Project:	M181 Southern Junction - Phase 2 B1450 Spur and East Roundabout		
Client:	North Lincolnshire Council		
Drawing:	Temporary Phase - Southern Ditch Diversion And Culverting Layout		
Role:	CIVIL ENGINEER		
Drawing Status:	FOR REVIEW & COMMENT	Suitability Code:	S3
Job. no.	53335	Scale@ A1:	1:500
Project	Originator	Zone	Level
SER- AWP	ZZ	05	D - C - 3101
Rev.	P02		Number

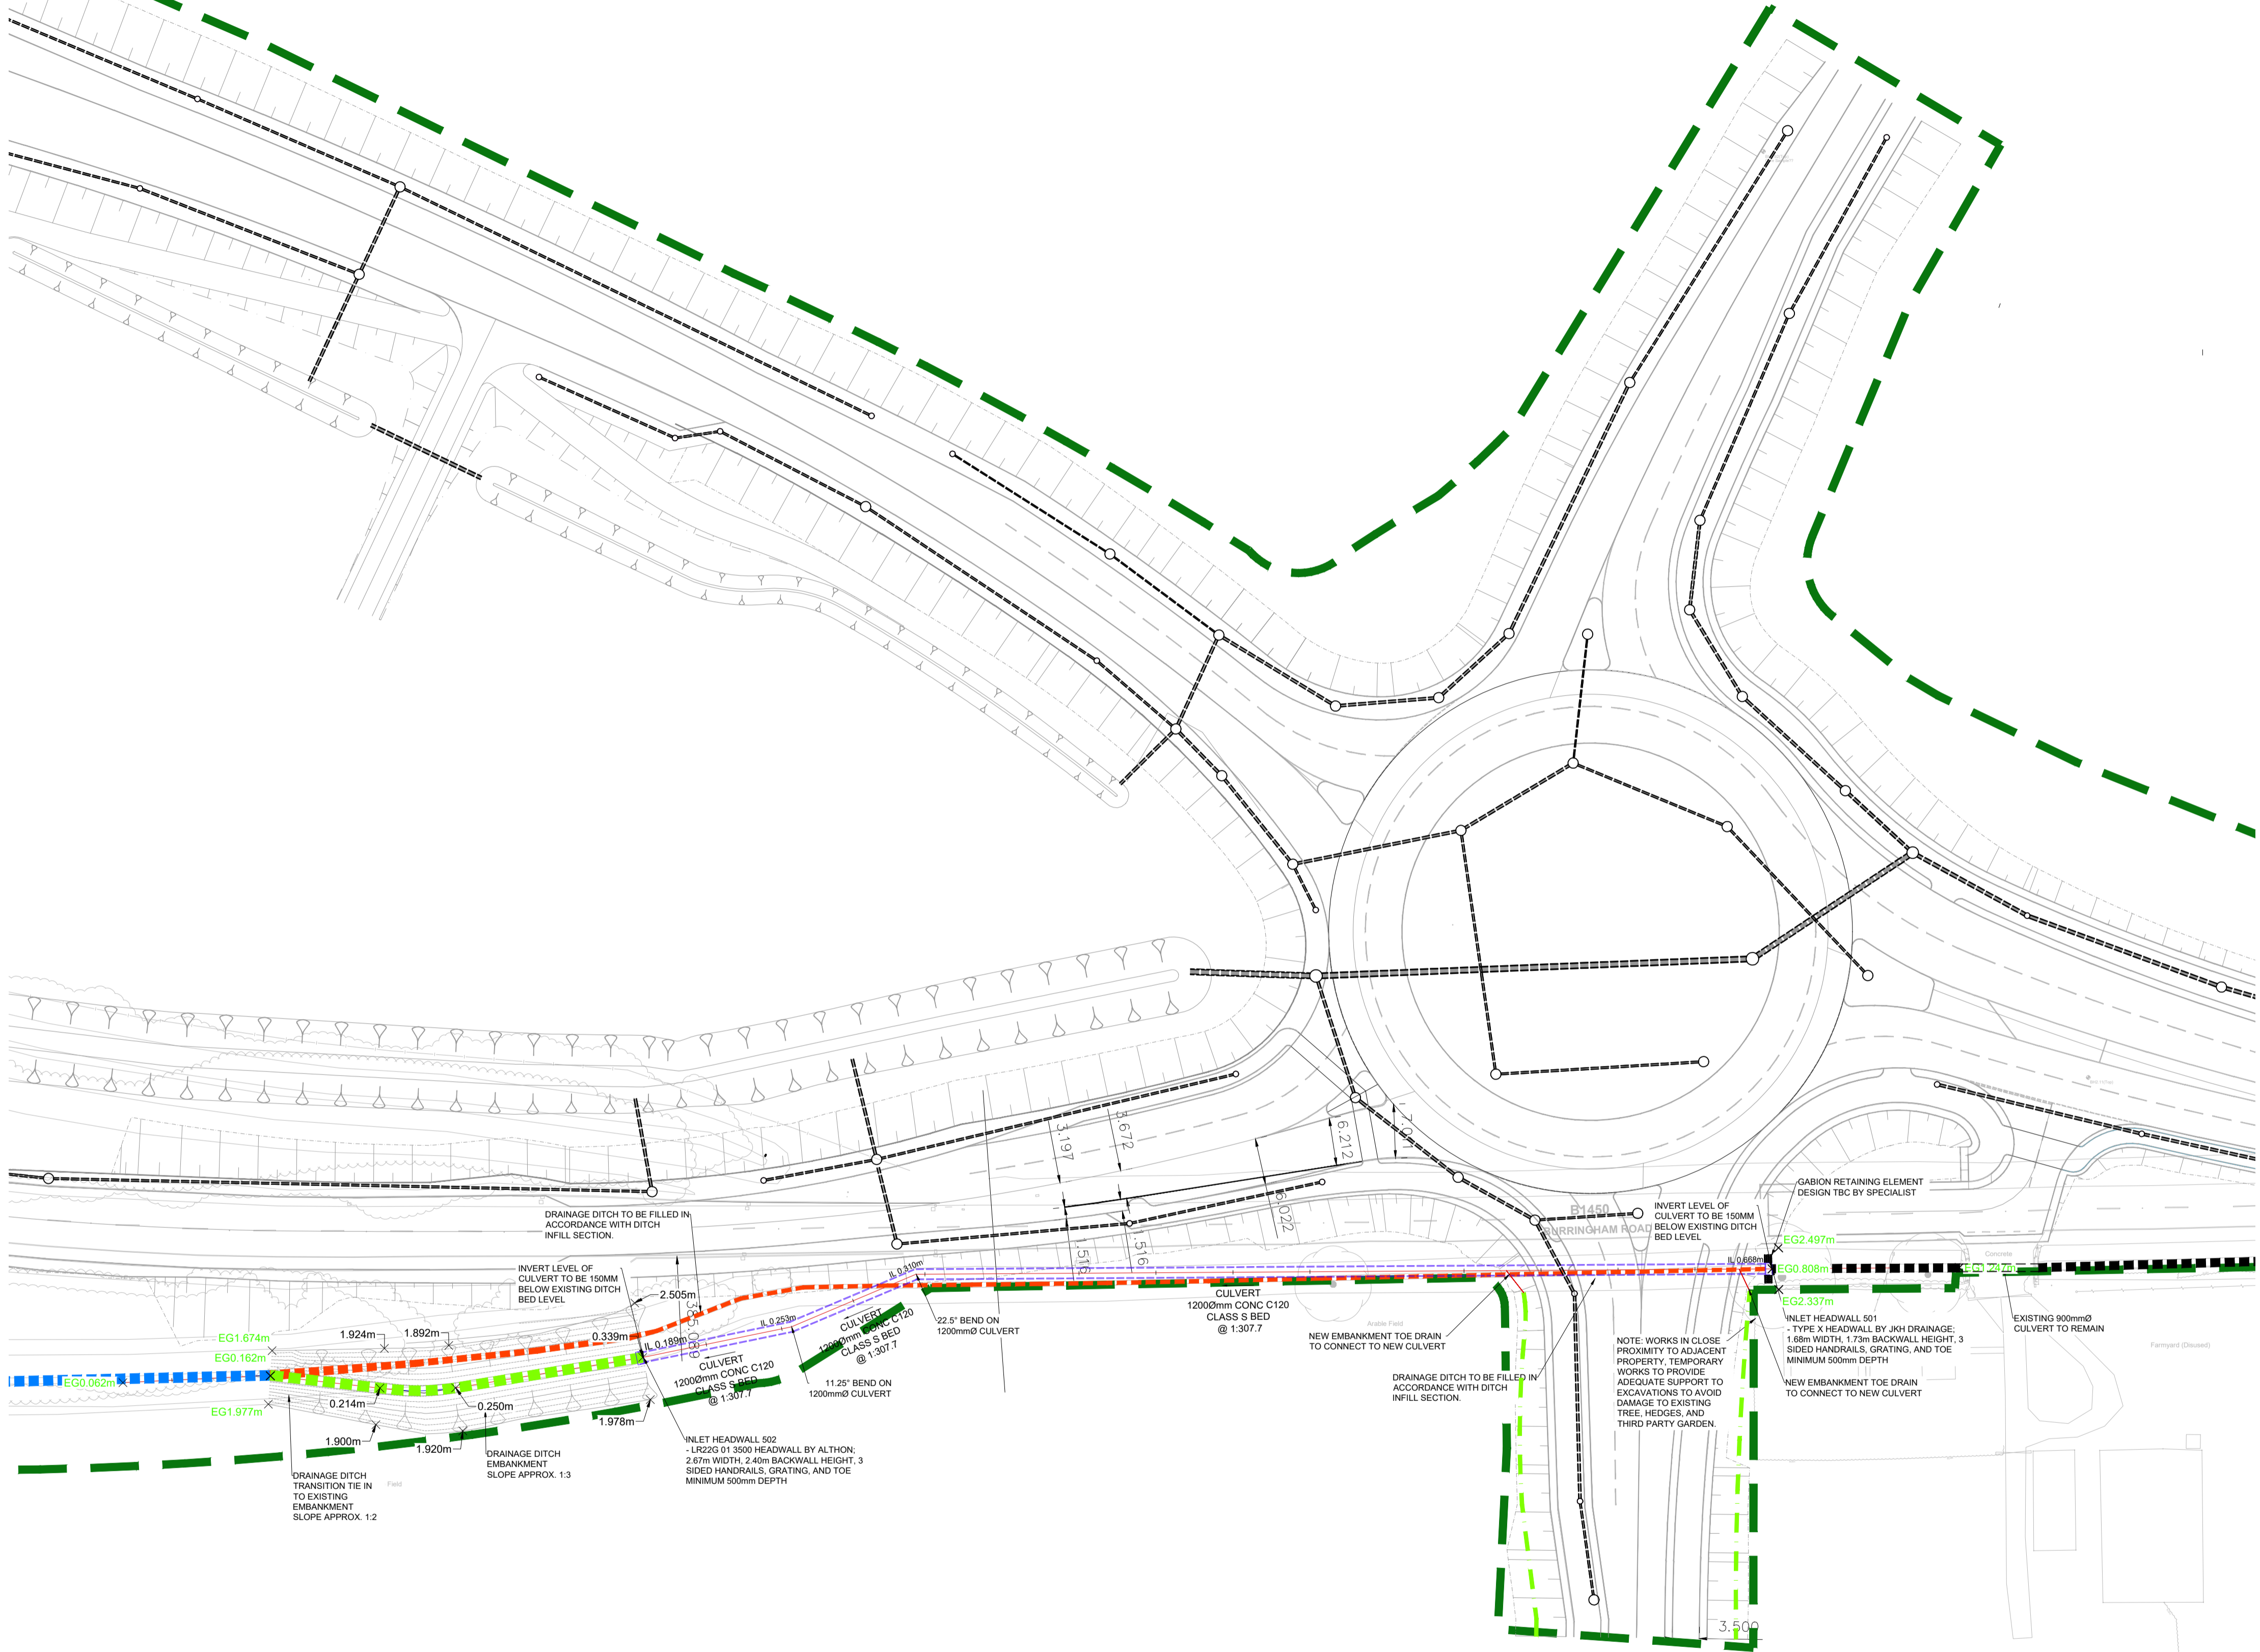
HEADWALL 502 SPEC CHANGED TO SUIT ALTHON LR22G 01 3500 HEADWALL. HEADWALL 501 AMENDED TO SUIT GABION REINFORCEMENT	26.03.26	ERD	JP	BH
P01 FIRST ISSUE	13.03.26	ERD	JP	SPG
Rev Description	Date	By	Crk	App
